## HISTORIC AND DESIGN REVIEW COMMISSION

**HDRC CASE NO:** 2019-145  
**ADDRESS:** 815 E ASHBY PLACE  
825 E ASHBY PLACE  
835 E ASHBY PLACE  
837 E ASHBY PLACE  
841 E ASHBY PLACE  
875 E ASHBY PLACE  
**LEGAL DESCRIPTION:** NCB 3053 BLK LOT 11, 12, 13 & 14 (4.635 AC) & P-100 (0.142 AC) & P-101 (0.3304 AC) TOTAL: 5.1074 AC  
**ZONING:** I-1, RIO-2  
**CITY COUNCIL DIST.:** 1  
**APPLICANT:** Ashley Farrimond/Kaufman & Killen, Inc., Embrey Partners, Ltd., AREA Real Estate, LLC, Humphreys & Partners Architects, L.P.  
**OWNER:** SSGT Borden Park LLC  
**TYPE OF WORK:** Construction of a 5-story, multi-residential structure, rehabilitation of an existing structure  
**APPLICATION RECEIVED:** March 18, 2019  
**60-DAY REVIEW:** May 17, 2019  
**CASE MANAGER:** Edward Hall  
**REQUEST:**

The applicant is requesting conceptual approval to:

1. Perform rehabilitative scopes of work to the Borden Building, the existing structure located at 875 E Ashby Place. Existing rear additions may be removed.
2. Construct a five-story, multi-family residential structure on the lots addressed as 815, 825, 835, 827 and 841 E Ashby Place.
3. Perform river beautification improvements, trail improvement

# **Site Plan**

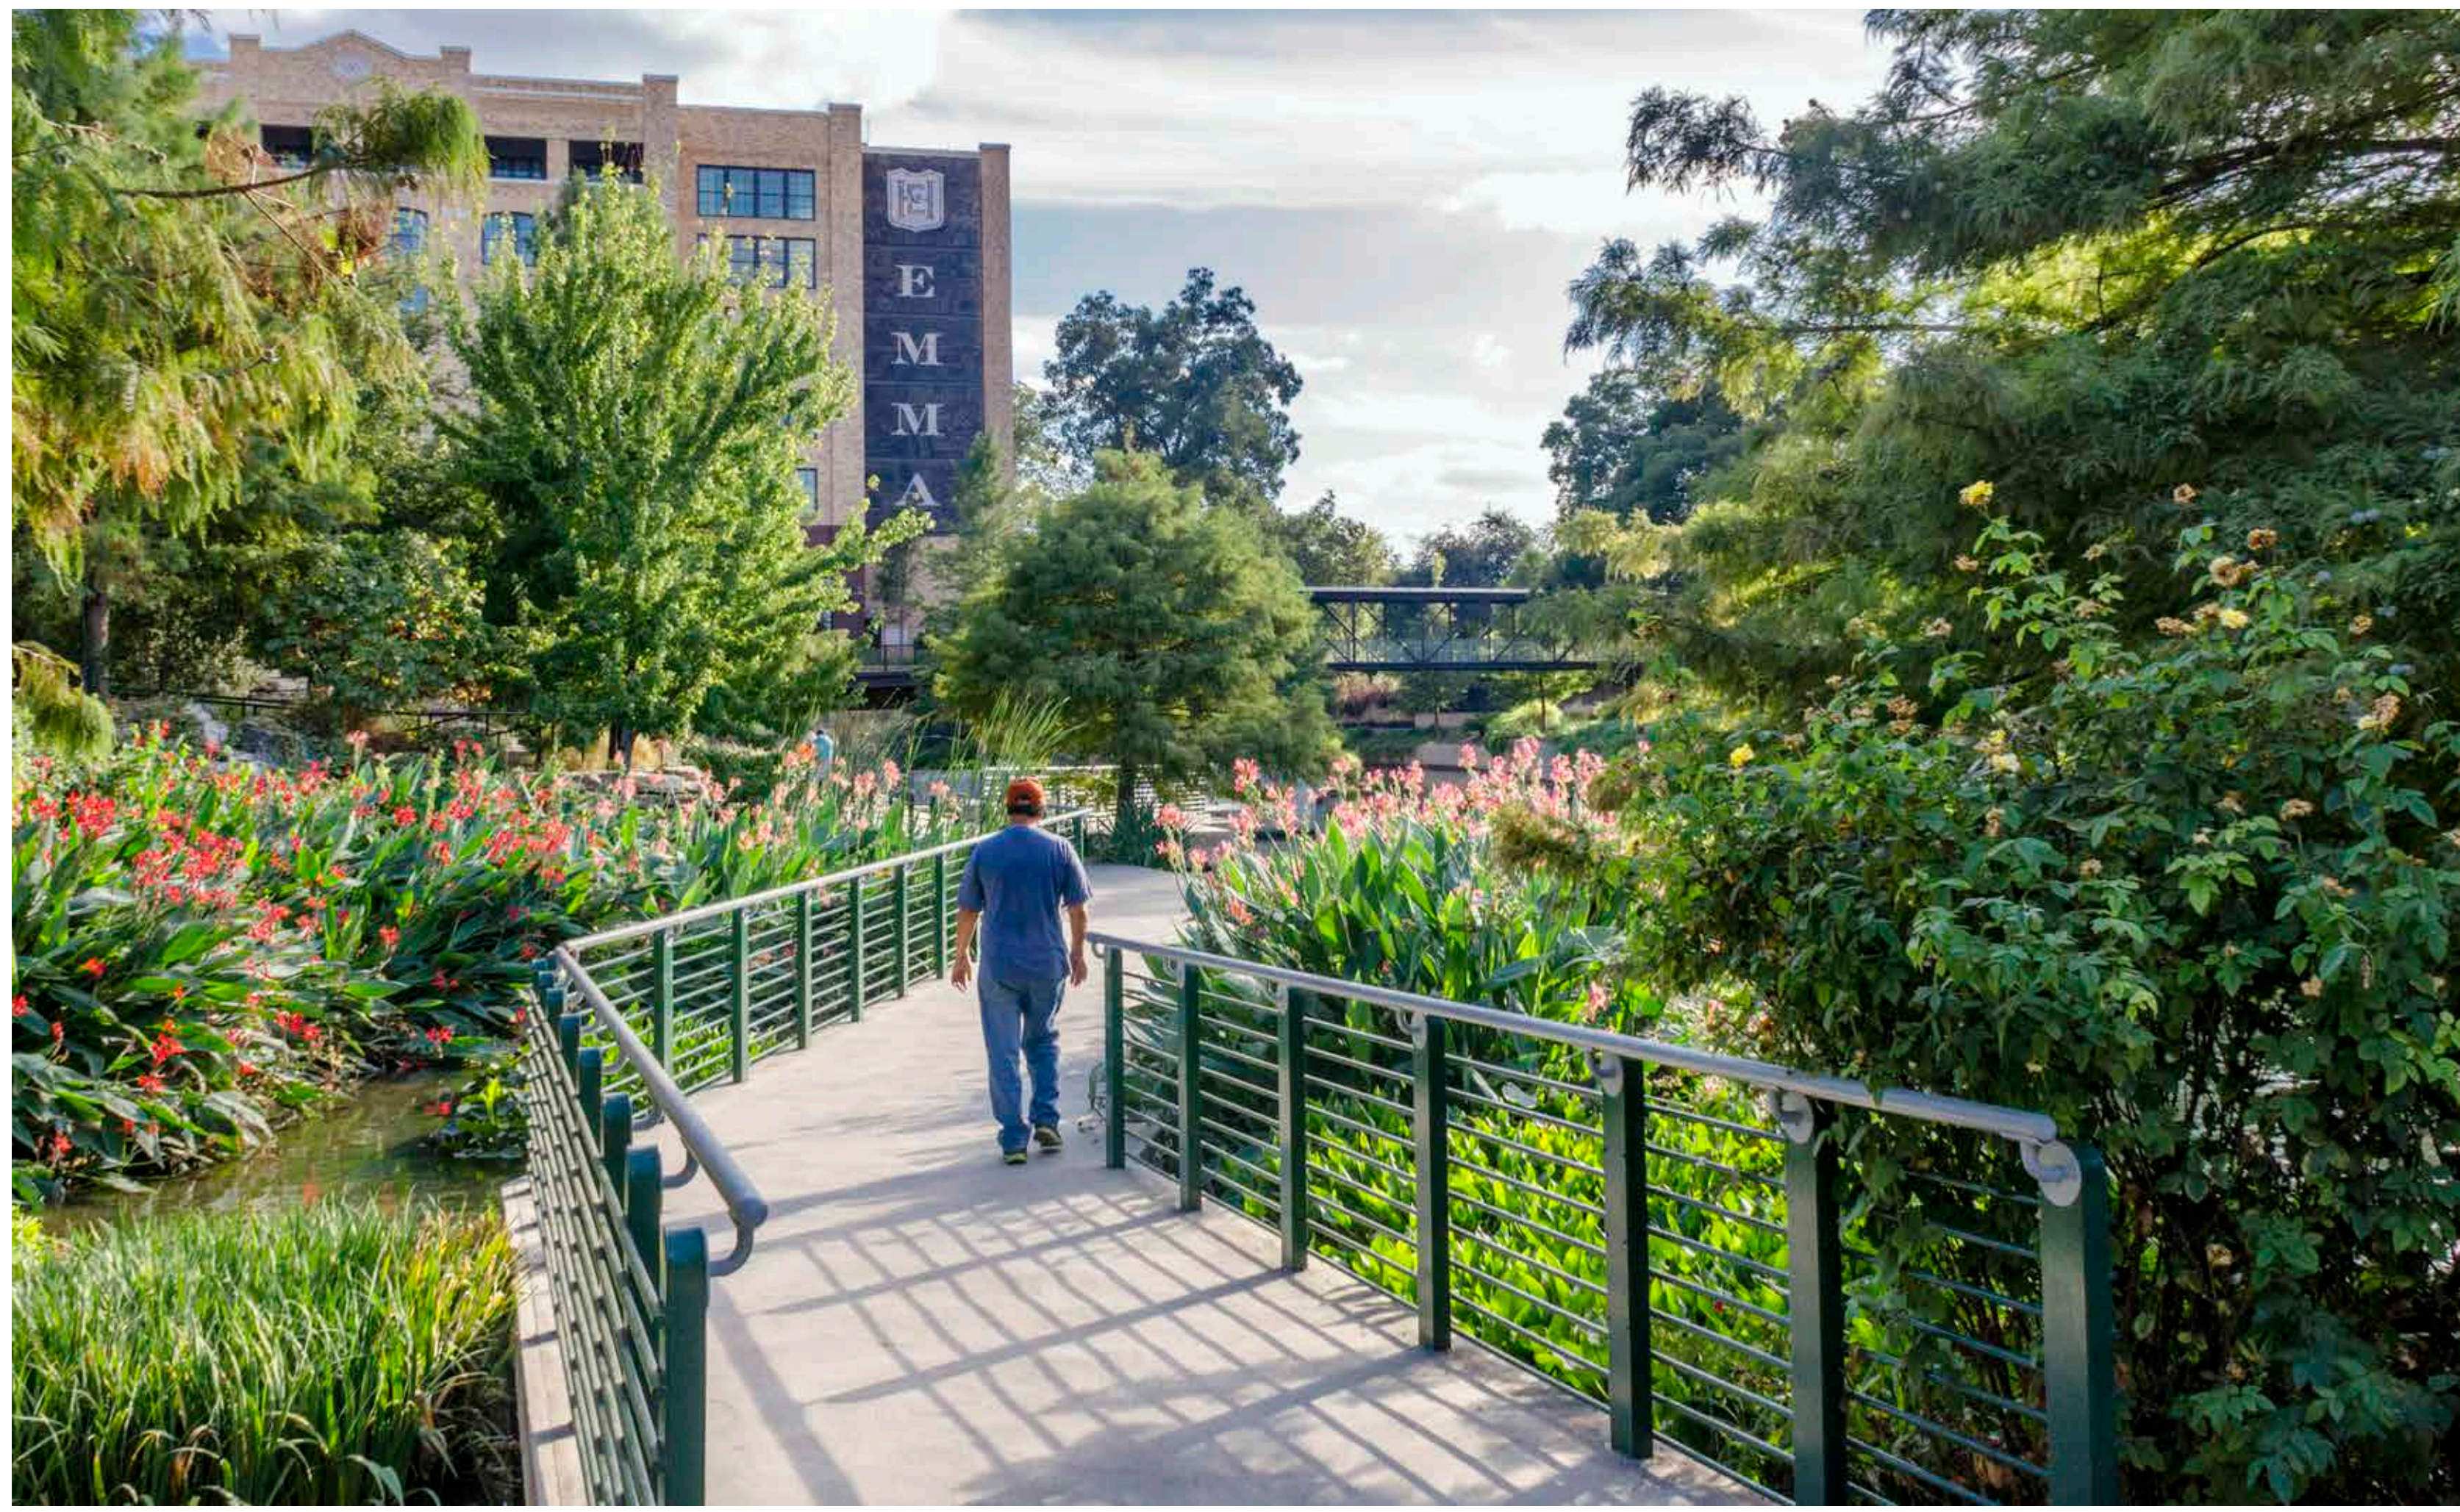
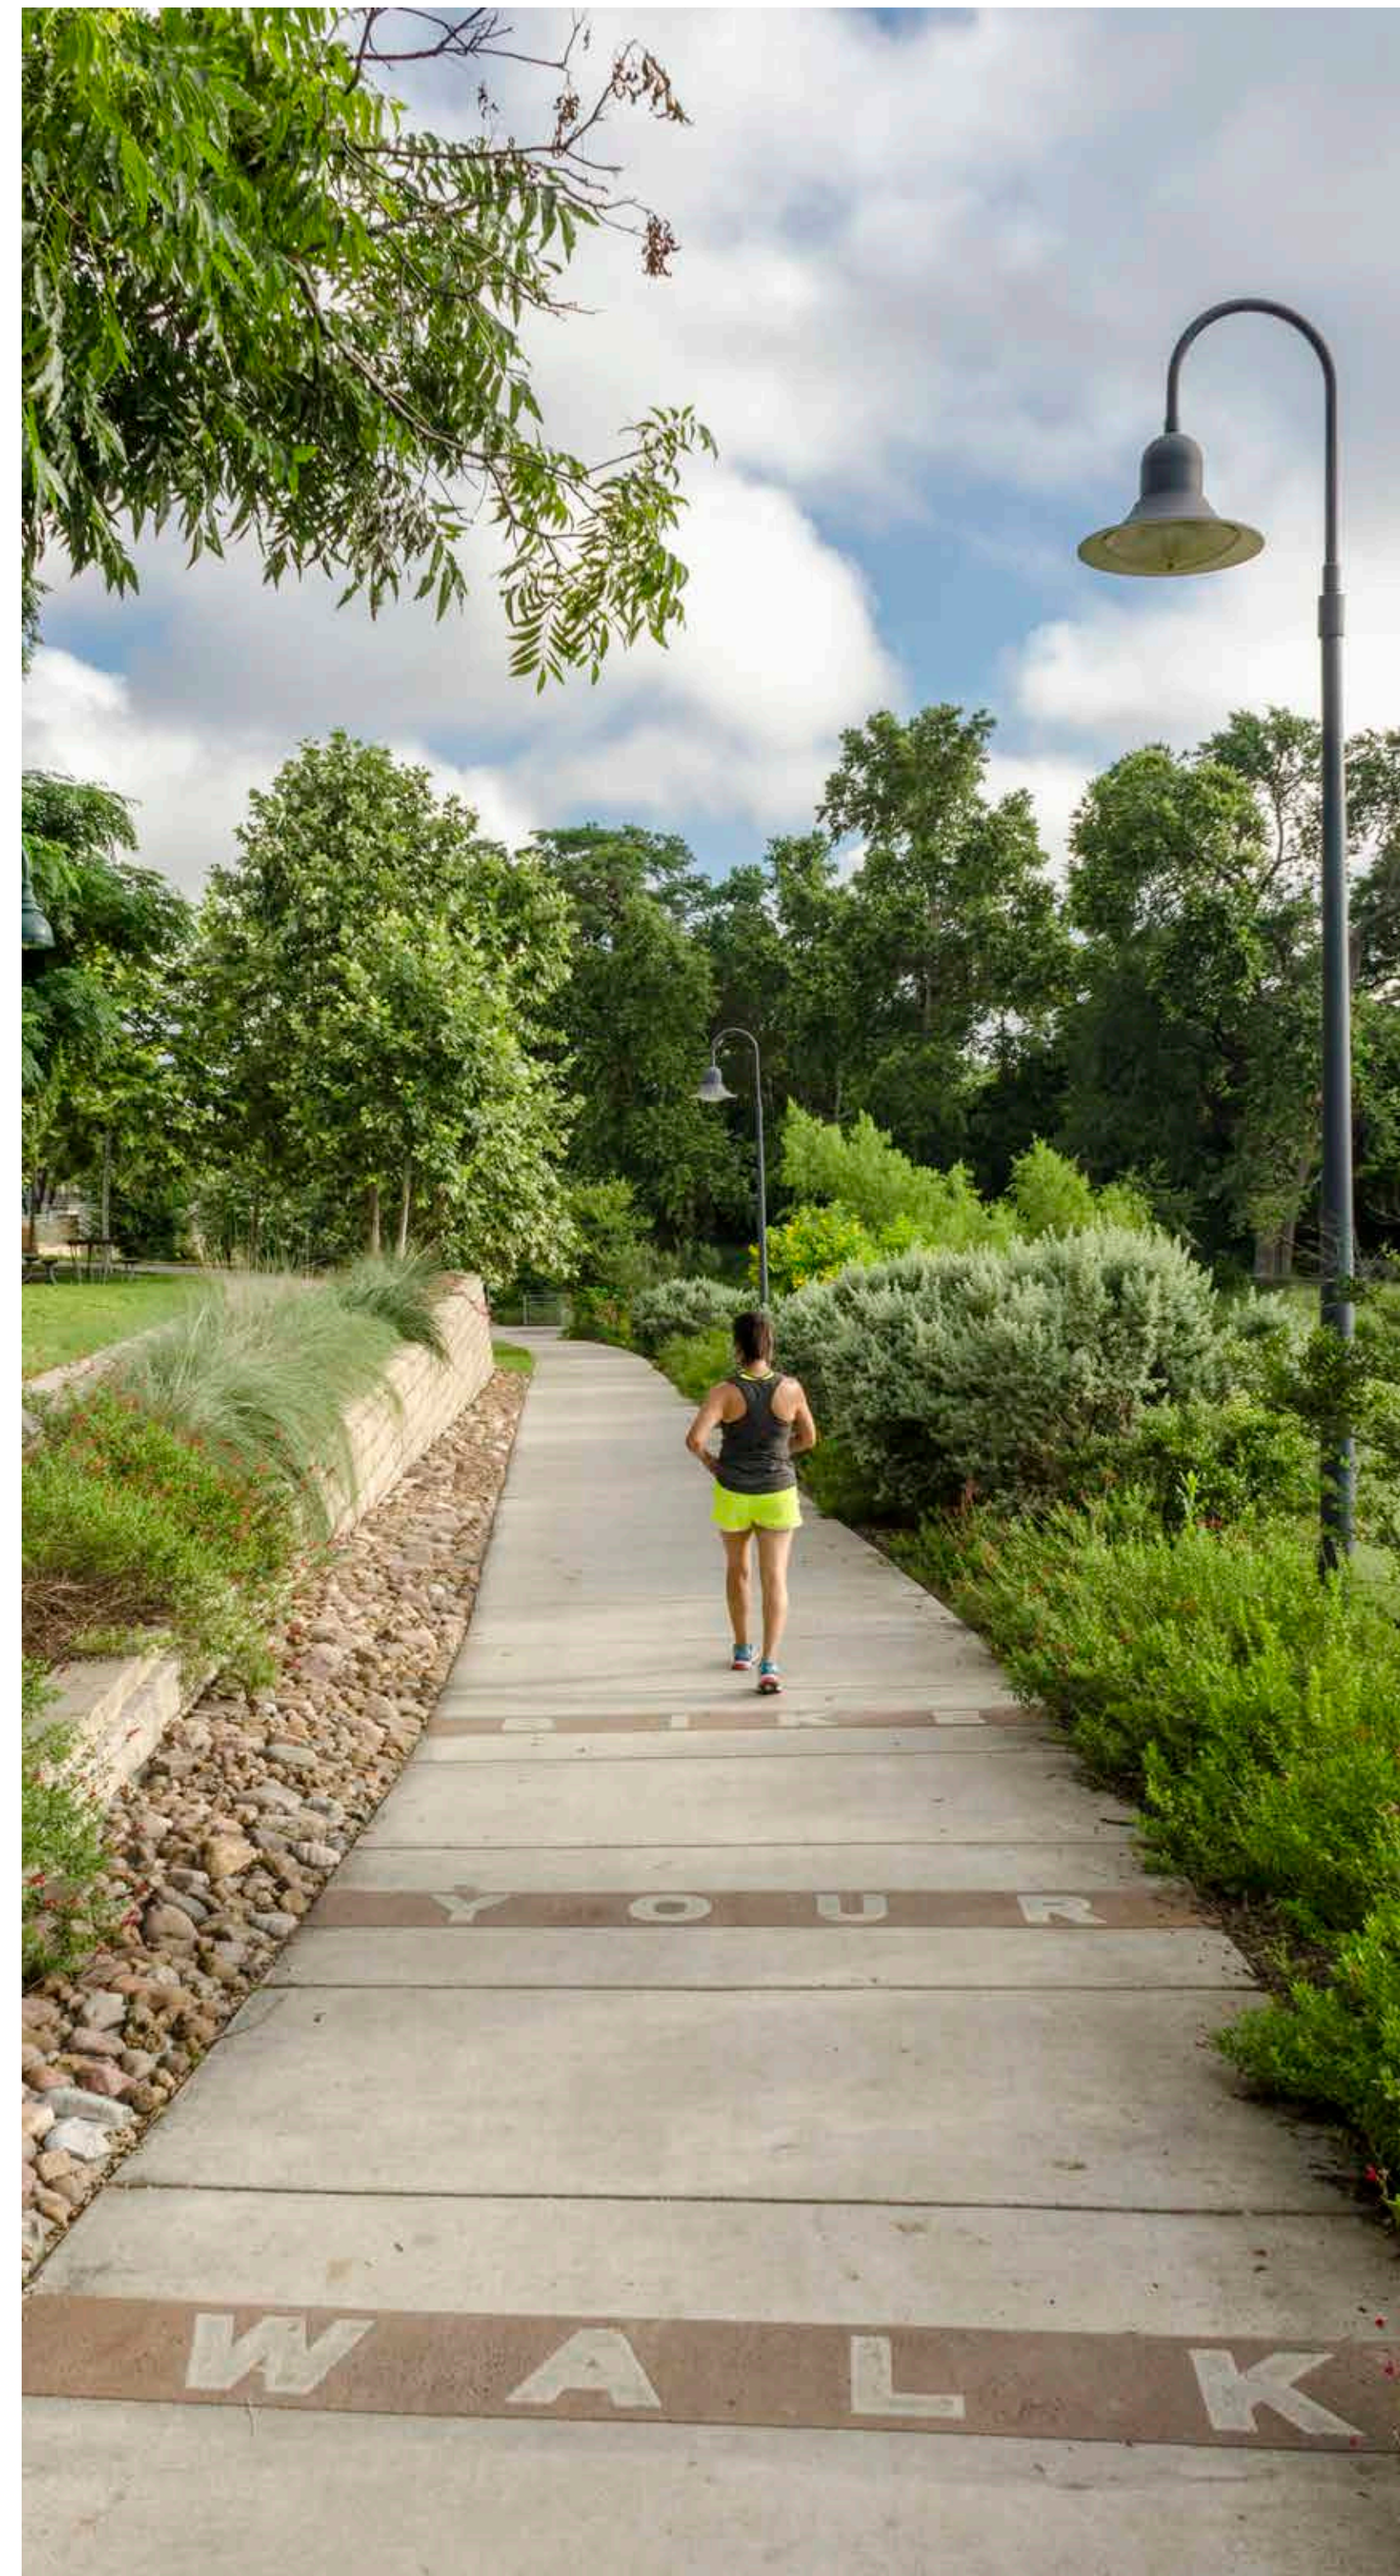
area users, provide pedestrian connections between sites, help animate the street scene and define street edges. Primary entrances should be oriented toward the street and shall be distinguishable by an architectural feature. The applicant has proposed to site the new construction adjacent to the right of way at E Ashby. Additionally, the applicant has proposed to remove the existing site paving that extends River Road into the site, adjacent to the San Antonio River. Staff finds the proposed site design to be appropriate and consistent with the UDC.

- 2f. LANDSCAPE DESIGN – The applicant has provided landscaping information on the conceptual site plan. The applicant is responsible for complying with the UDC in regards to landscape design.
